Clause 173 PMA bit-muxing constraints

(In support of comment #27 against D1.1)

Adee Ran, Cisco

Illustration – 32:8 PMA

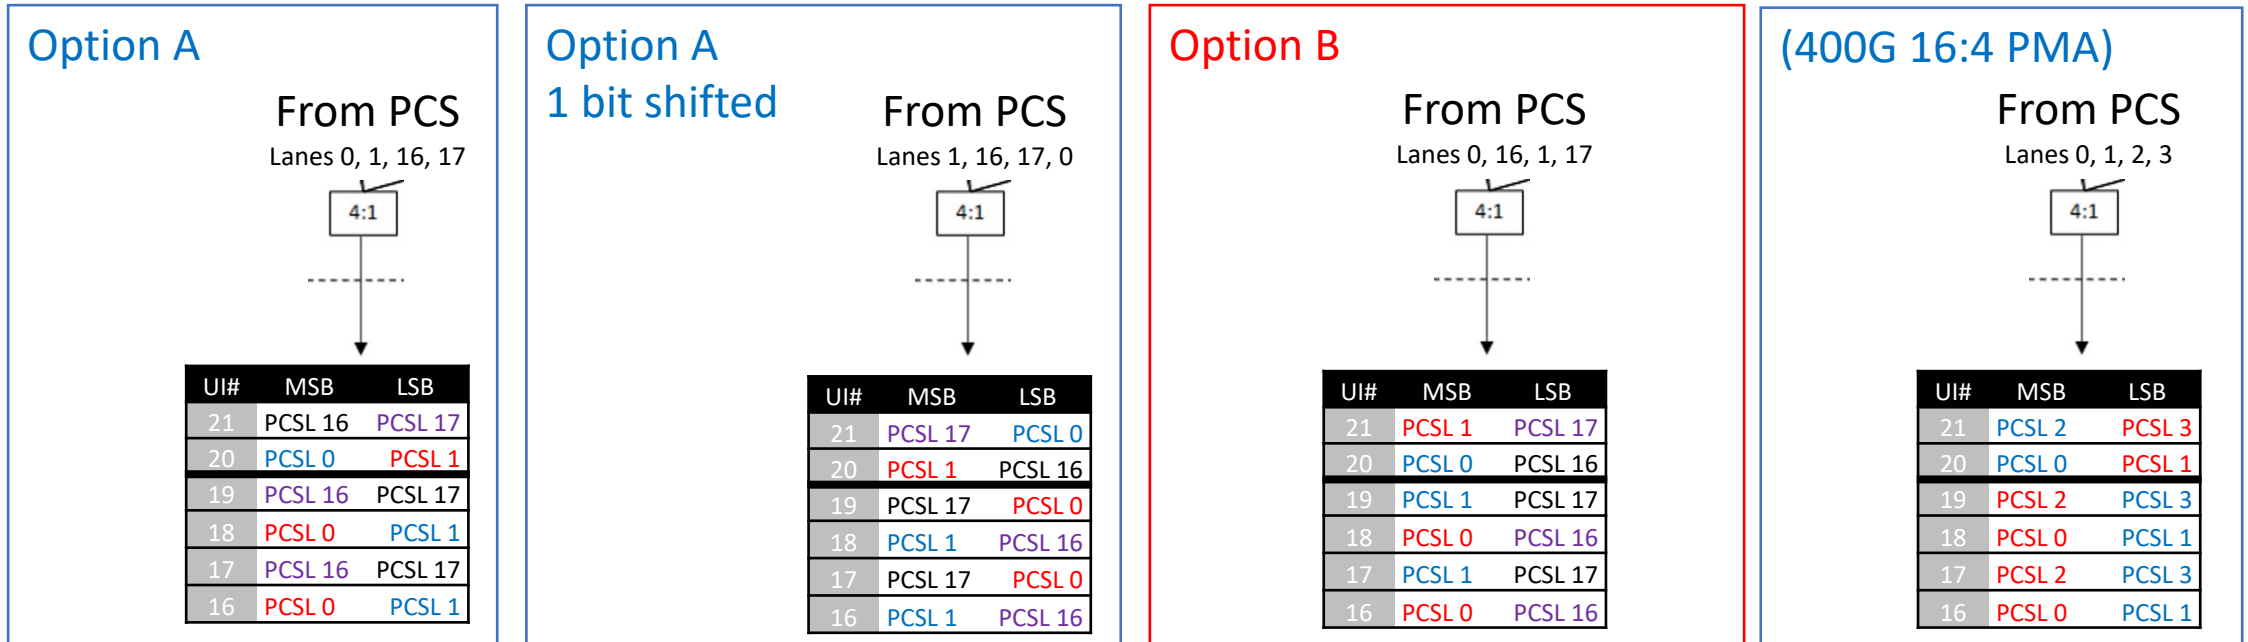
PCSL content of each PAM4 symbol in one physical lane
 In this example, the lane muxes PCSLs 0, 1, 16, and 17 (per the restrictions in D1.1)

The LSB is shared by both flows
 and all 4 codewords (A/B/C/D)
 Average BER is the same for all codewords

The LSB is only assigned to one flow
 Two codewords (C/D) always get the LSB
 Average BER is higher for these codewords

The LSB is shared by both
 codewords (A/B)
 Average BER is the same

Illustration – 8:8 PMA

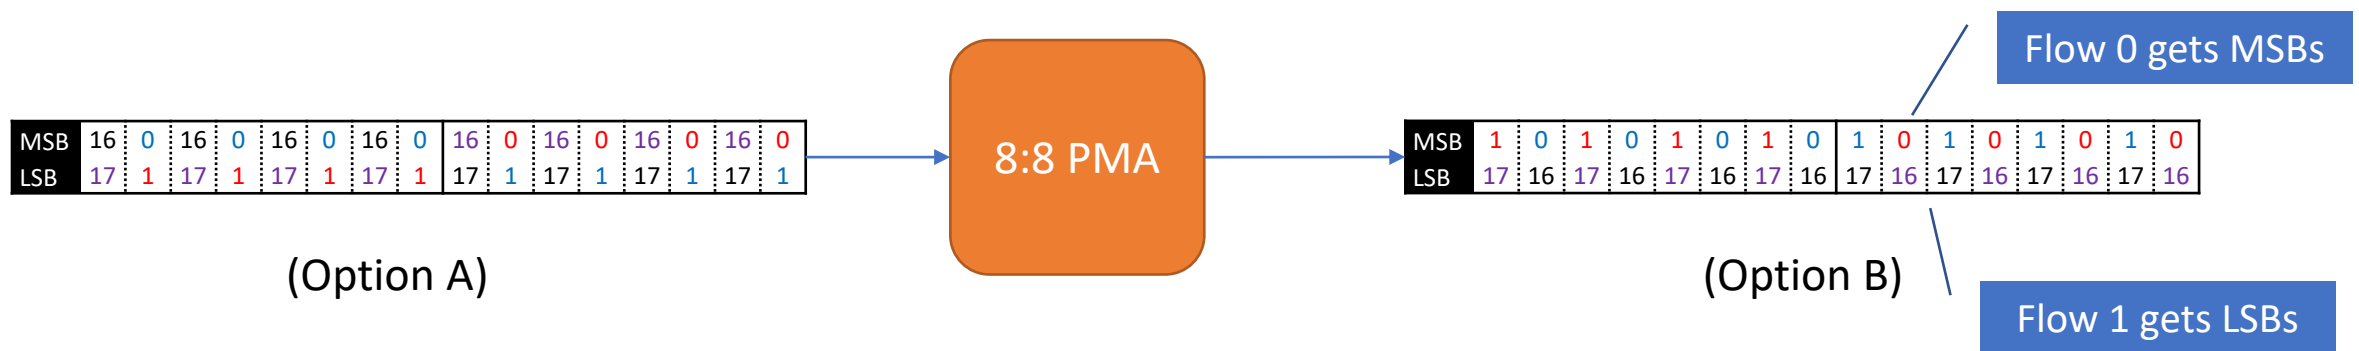
Currently:

“The order of PCSLs from an input lane does not have to be maintained on the output lane”

So even if the 32:8 PMA does the muxing wisely, a retimer or module is allowed to **reorder the bit stream from (0, 1, 16, 17) to (0, 16, 1, 17)...**

This would cause the following effect:

- The 4 PCSLs received on ~~any~~an input lane shall be mapped to ~~the same~~an output lane such that the Gray-coded PAM4 symbol sequence on the output lane is identical to the Gray-coded PAM4 symbol sequence on the input lane (see 173.4.7.1). ~~The order of PCSLs from an input lane does not have to be maintained on the output lane.~~

This prevents a module or retimer from converting option A into option B

Implications

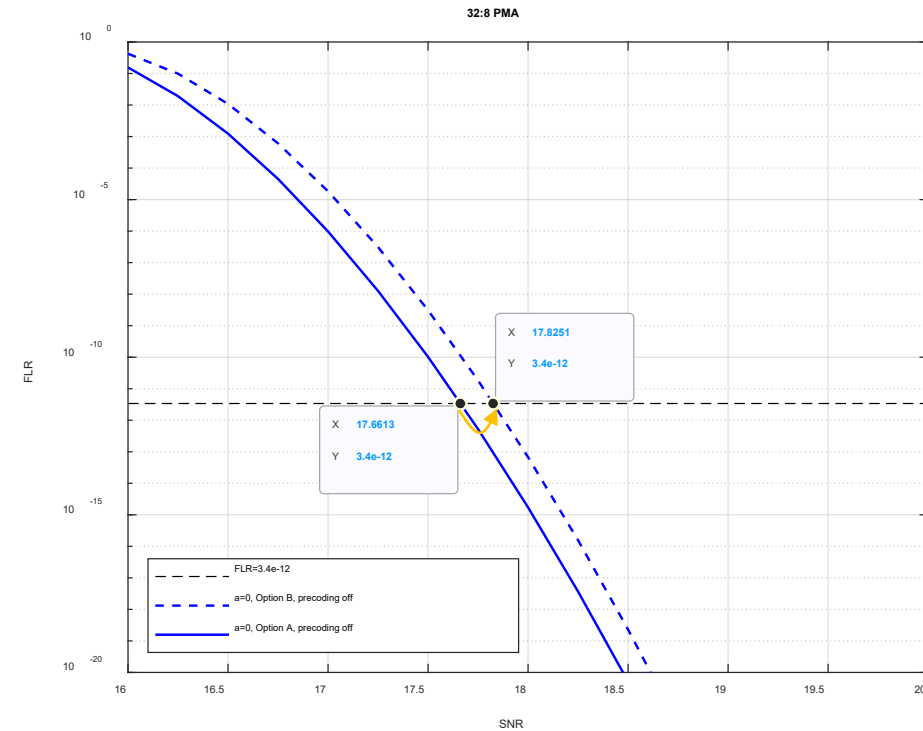
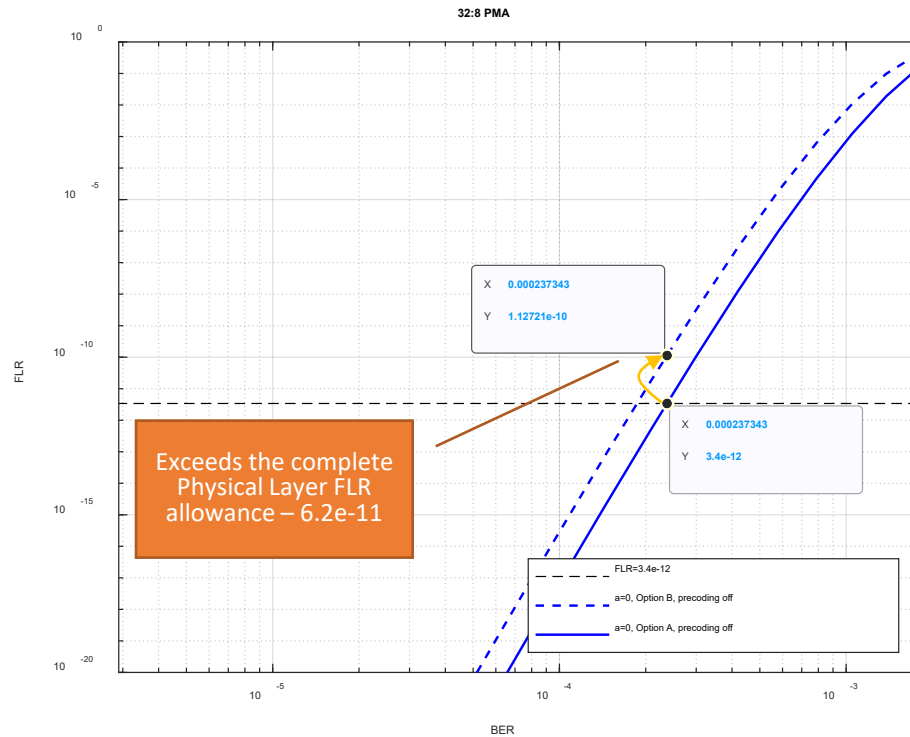
- An uncorrectable codeword invalidates the 3 other codewords interleaved with it
 - Causing loss of up to 33 MAC frames
 - x2 FLR compared to 400G/200G PHYs (2-CW interleaving) – already discussed; insignificant

- Data loss event frequency is the same
- Having only LSBs in a codeword creates a 33% higher BER for that codeword compared to balanced MSB/LSB (as in 400G/200G PHYs)

- 0.15 dB (electrical) SNR penalty
 - Frequency of uncorrectable codewords (data loss event) increase x34 (due to FEC coding gain)
 - Combined FLR is x68 compared to 400G/200G PHYs!

- “Once per month” in 2x400G becomes “more than daily” in 1x800G.
 - “Once per year” in 2x400G becomes “more than weekly” in 1x800G.
- A device that uses “option B” on its transmit path creates a higher FLR and more data loss events **for its link partner.**

- This can hinder troubleshooting...
- This happens:
 - Regardless of where the errors happen (any optical/AUI receiver whose transmitter uses the “option B” order)

- Regardless of receiver structure.

Does not happen if precoding is used (but currently precoding is defined only for electrical links).
